MEMORANDUM

RE: Historic District Permit Application, Daniel Boggs: 640 Water Street

AMK PROPERTIES - SAUGATUCK BUILDING

PROJECT:
Saugatuck Building
640 Water Street
Saugatuck, MI 49453

SHEET TITLE:
Concept

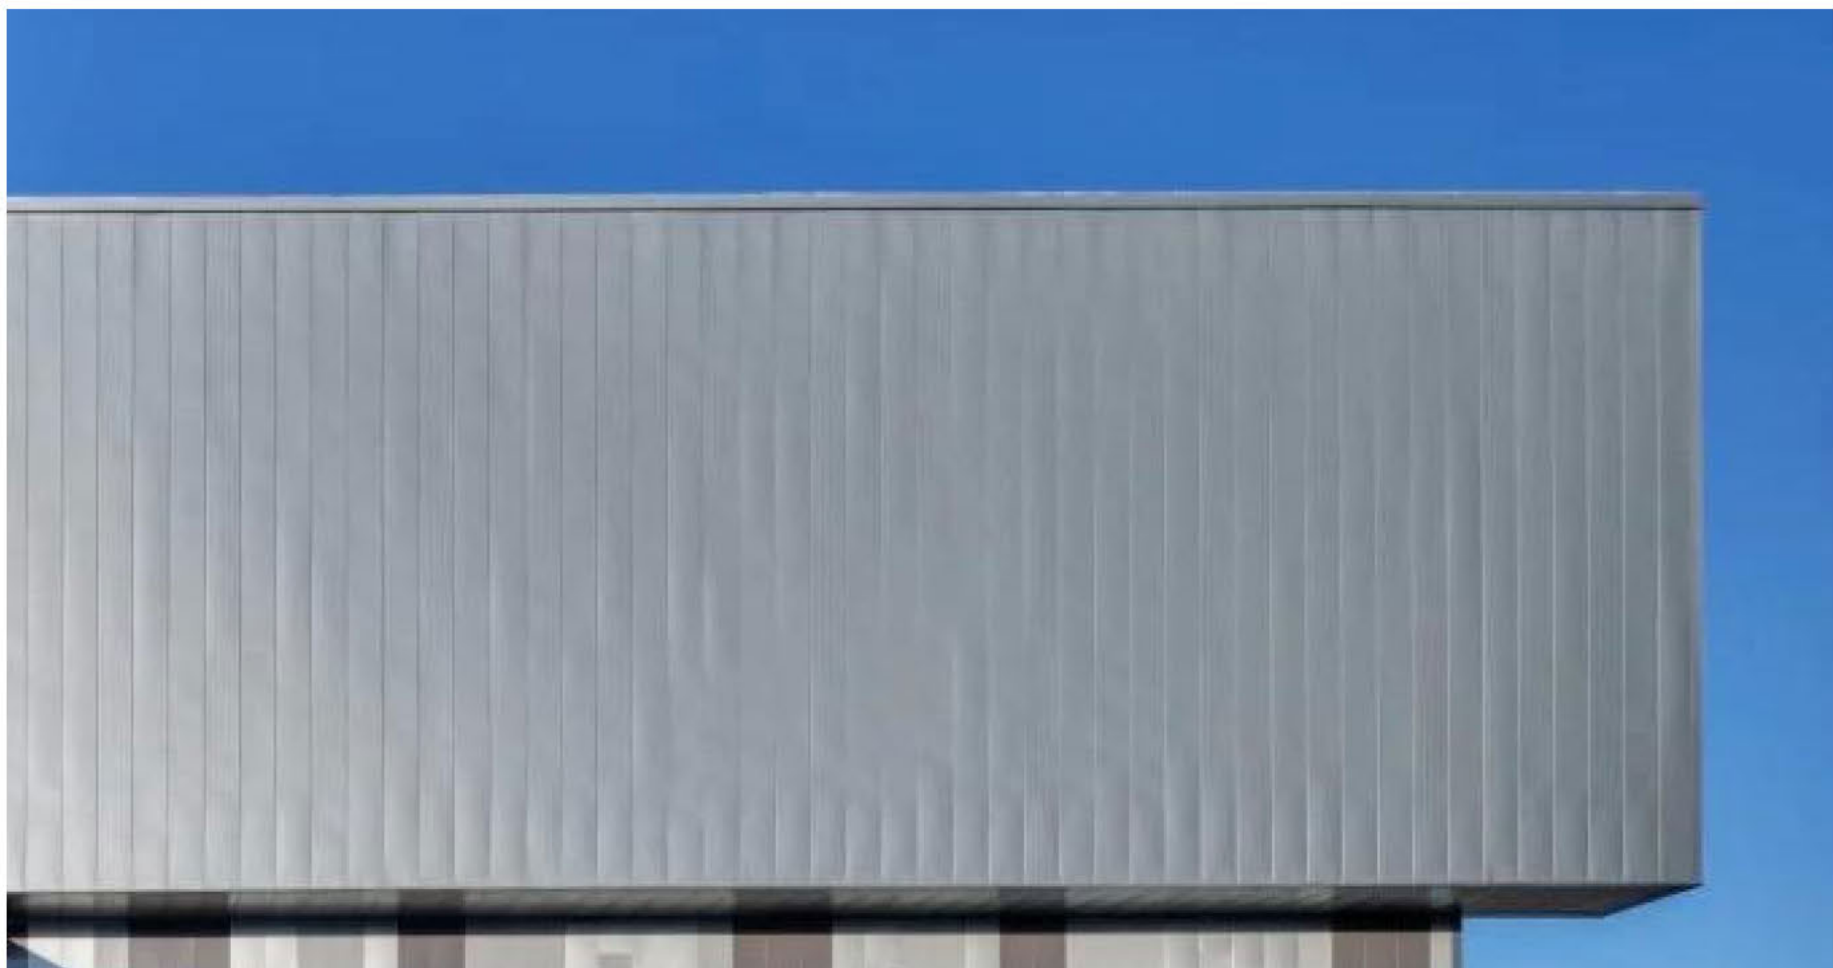
Comment: The design represents a contemporary interpretation using traditional forms and materials common to the district, consistent with the guideline allowing compatible modern adaptations. The applicant has proposed wood siding to simulate the wood clad boat cabin of historic fishing tugboats and metal siding with subtle reveal joints to simulate the tugboats metal clad haul.

3 SITE PLAN - MODIFICATIONS TO BE SOUGHT
SCALE: 1" = 20'-0"

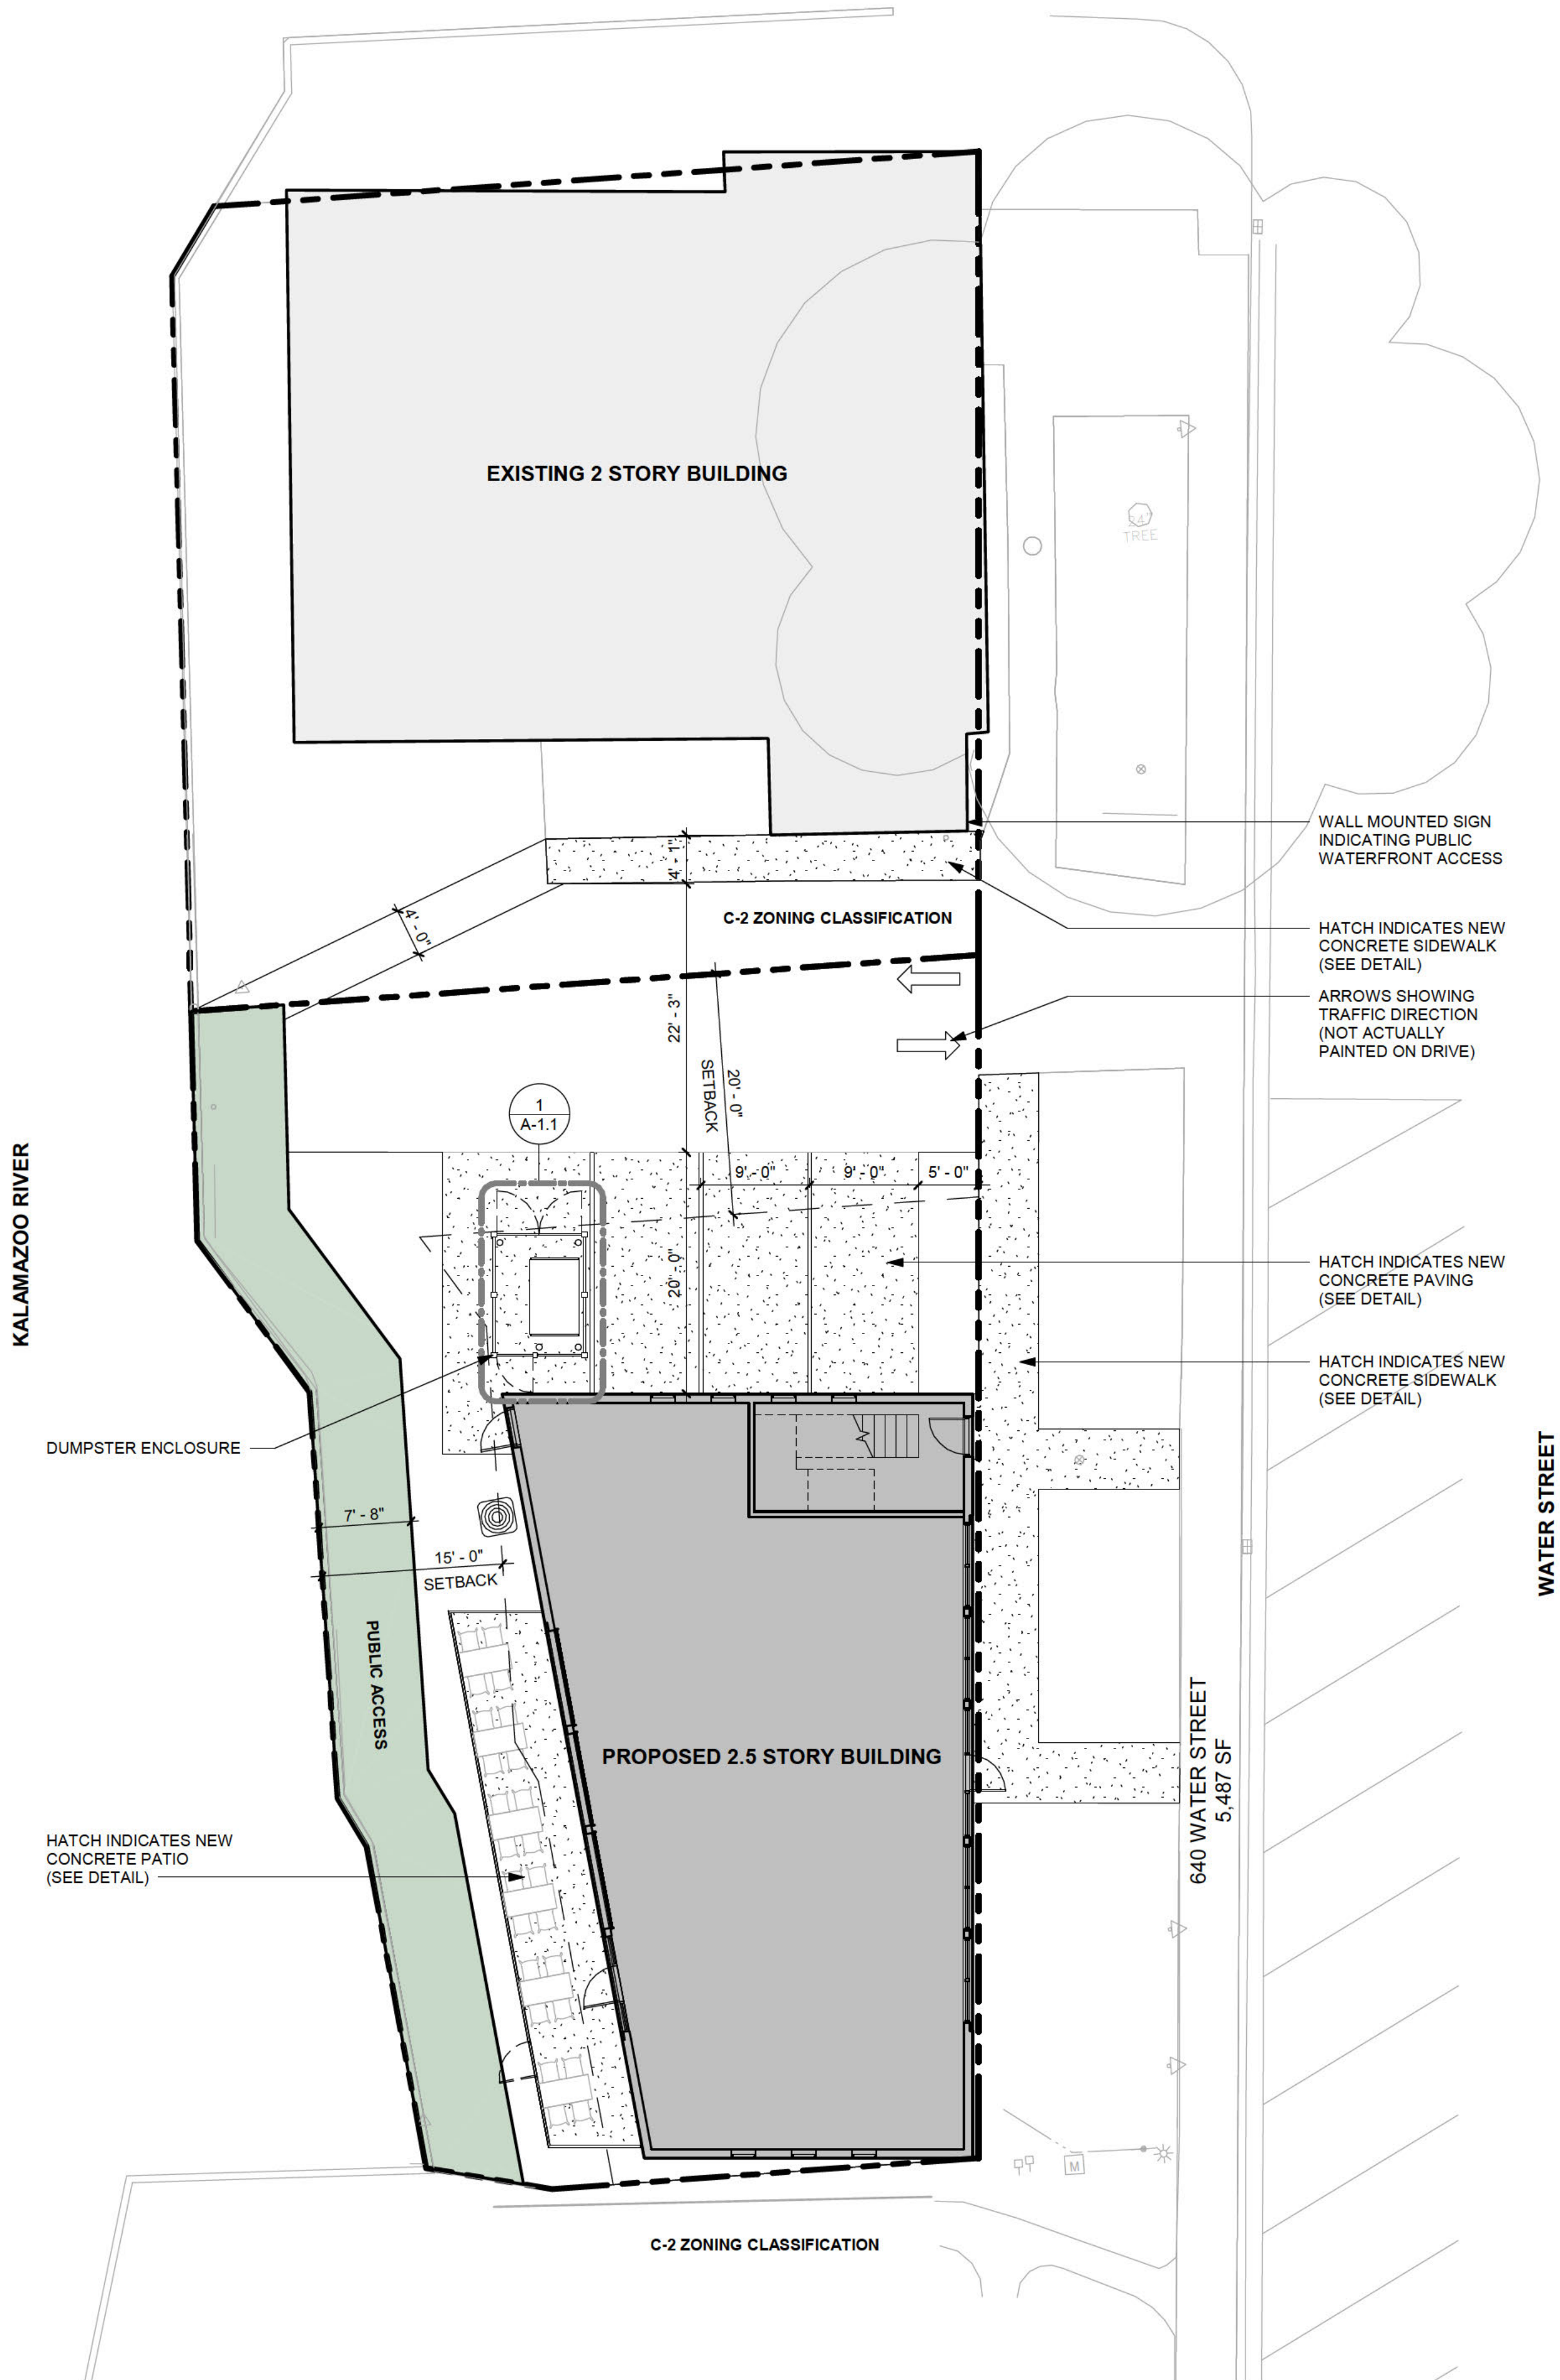
The building footprint occupies much of the shallow lot, necessitating dimensional deviations addressed through the PUD, including a zero-foot front setback and a reduced waterfront setback of approximately 15 feet (compared to the standard 25 feet). The building is two and a half stories.

The Planning Commission also recommended a parking lot modification to reduce the setback from 20 feet to five feet along the right-of-way. However, the visual impact of the parking area will be buffered by compliant landscape screening. A screened dumpster pad is proposed behind (west) of the three proposed parking spaces. The dumpster screening materials and final design details have not been specified. However, the plans show the enclosure to have similar materials to the proposed building's second story with black trim and posts. This material is pine shiplap with nickel gap in a custom color shown on the plans.

Comment: The proposed building maintains a zero-foot front setback that is consistent with the established street wall along Water Street and is oriented towards the street and the Kalamazoo River. The relationship between the building, the shallow lot configuration, and surrounding development reflects existing downtown patterns of placement and spacing. Dimensional deviations, including the reduced waterfront setback, are addressed through the Planned Unit Development approval, and the proposal does not exceed the general height or bulk of surrounding development.
